**TOWN OF BLACKSTONE, MASSACHUSETTS
WATER TREATMENT PLANT
CONTRACT 2020-1, DWSRF 6686**

ADDENDUM NO. 1

1
H101C
1/2" = 1'-0" 0 1' 2' 4'

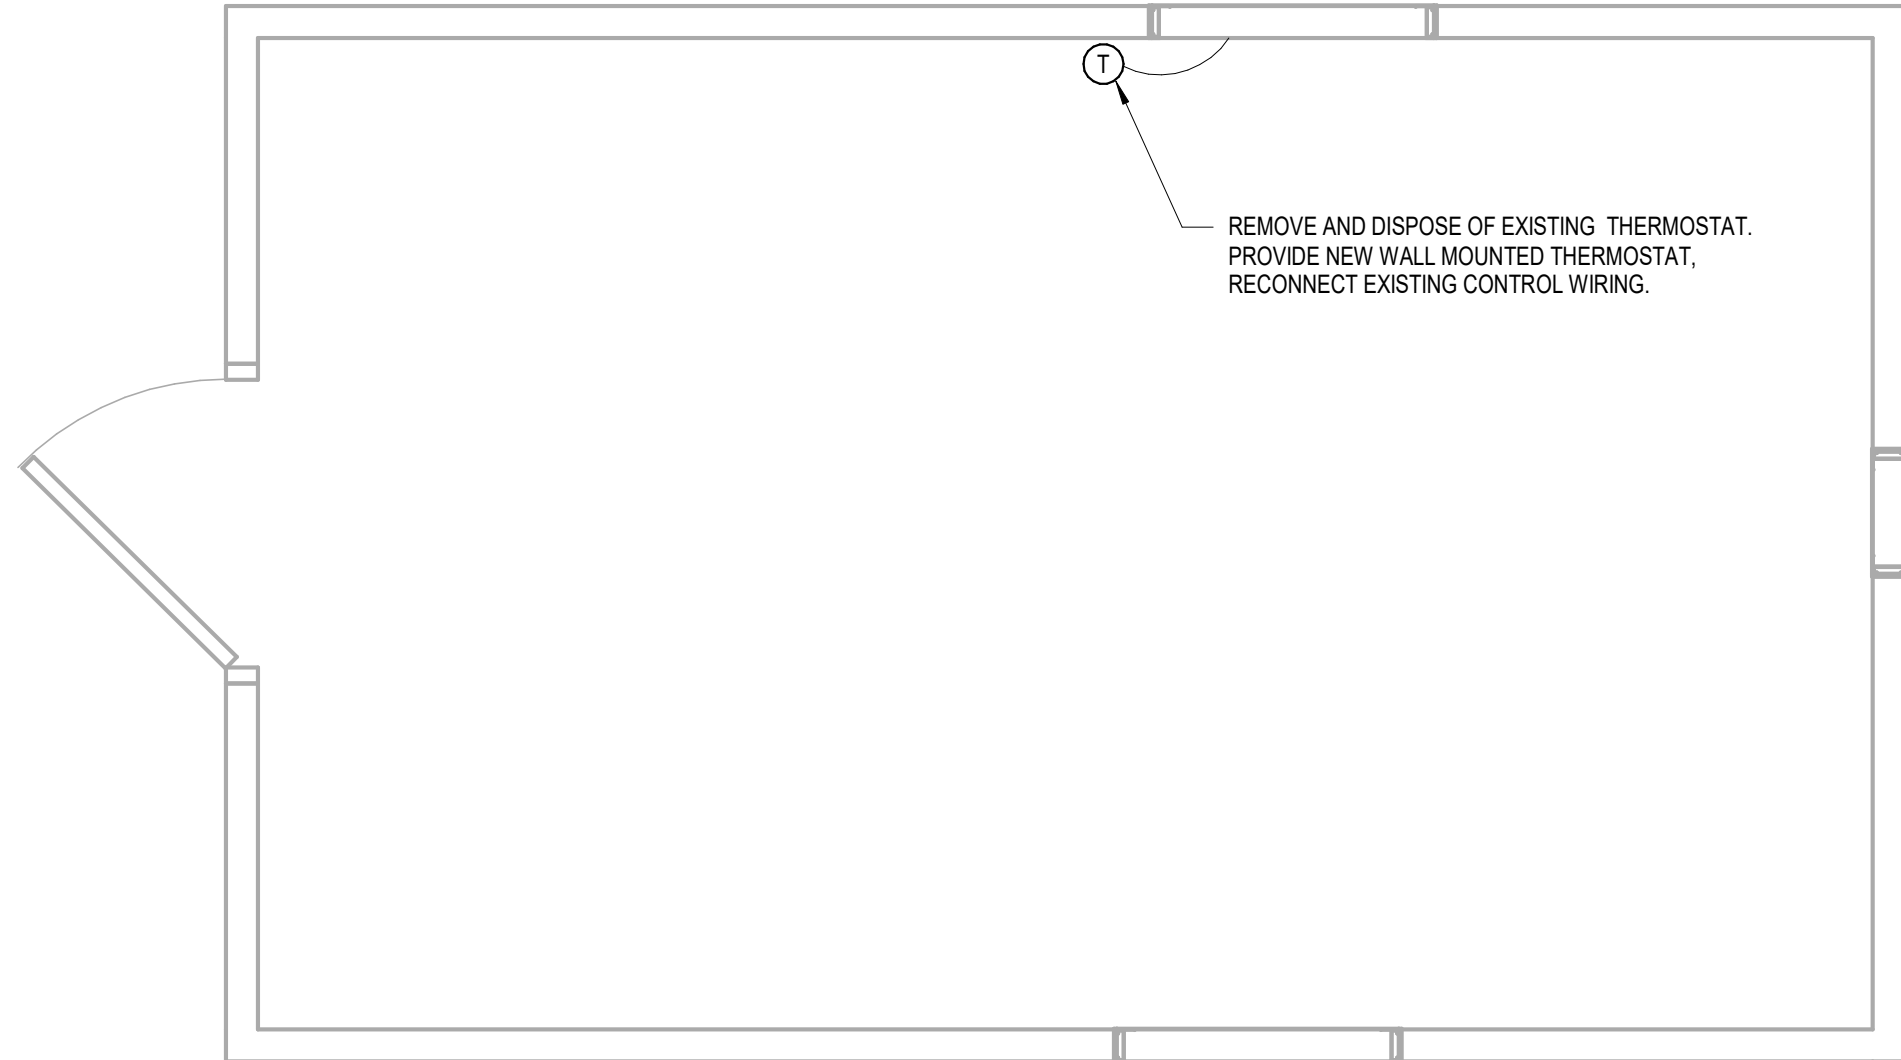
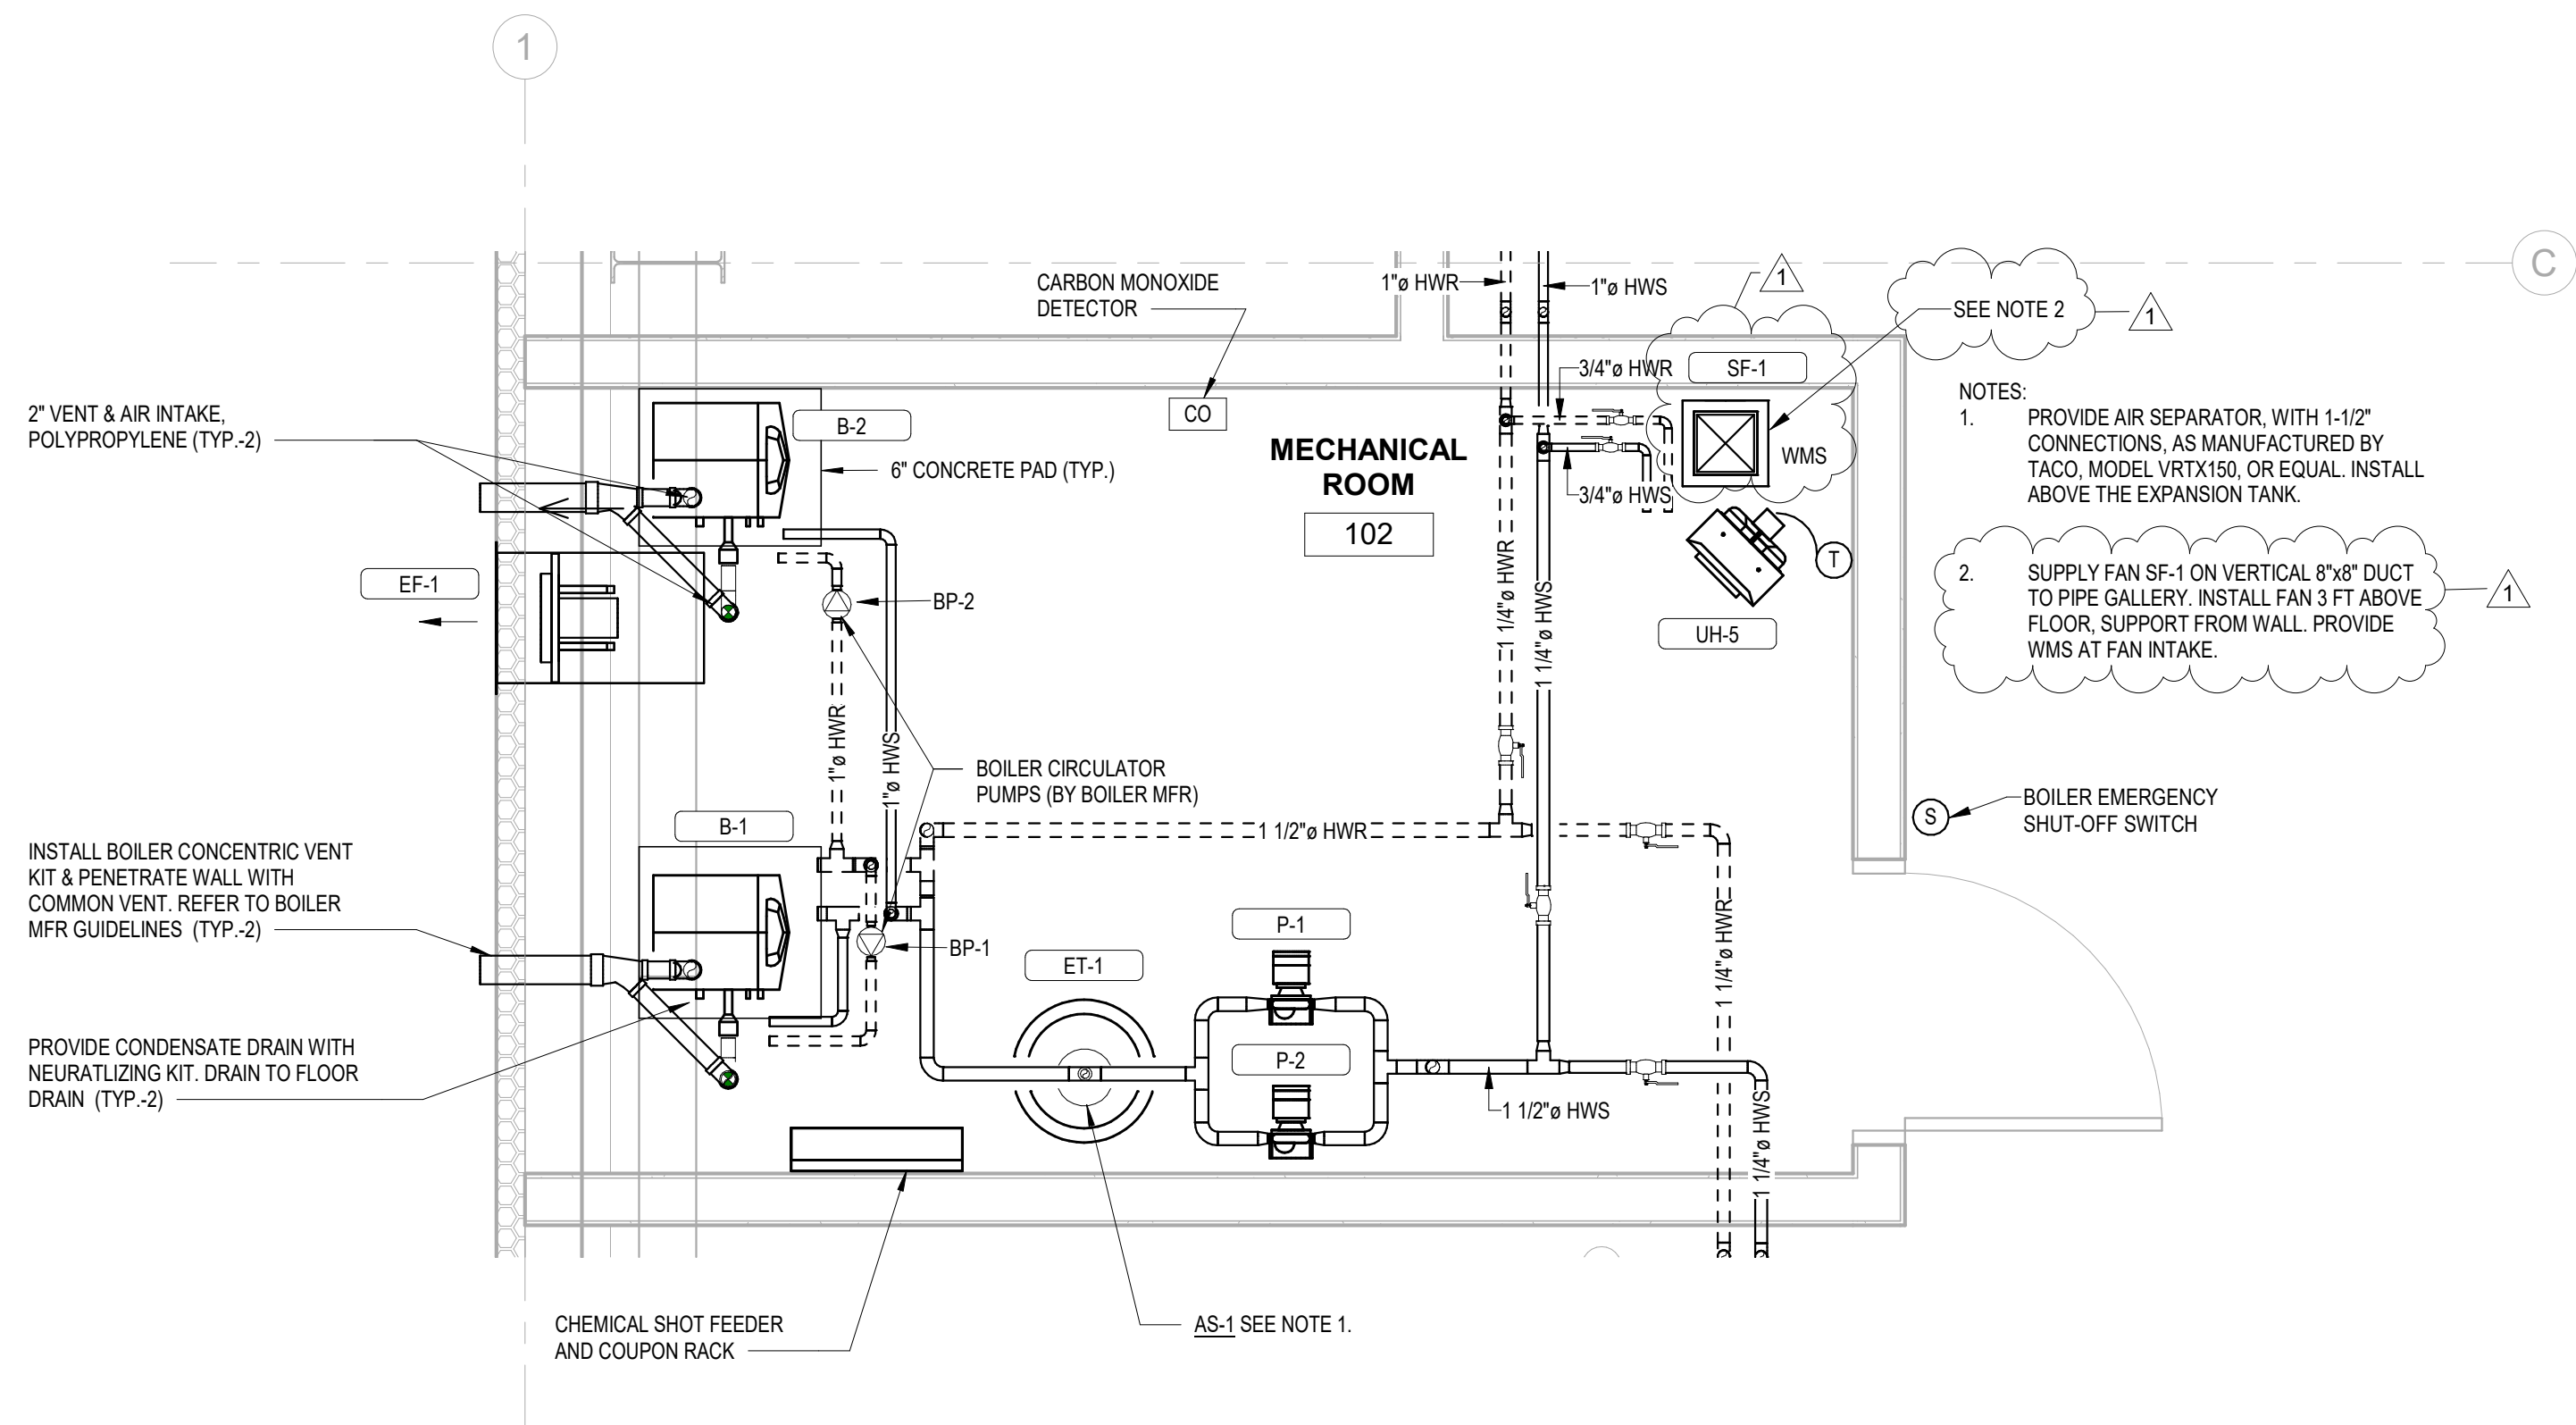
1. Delete “Sheet H101C” in its entirety and replace with attached “Sheet H101C – Well No. 2 and 6 HVAC Floor Plans”.
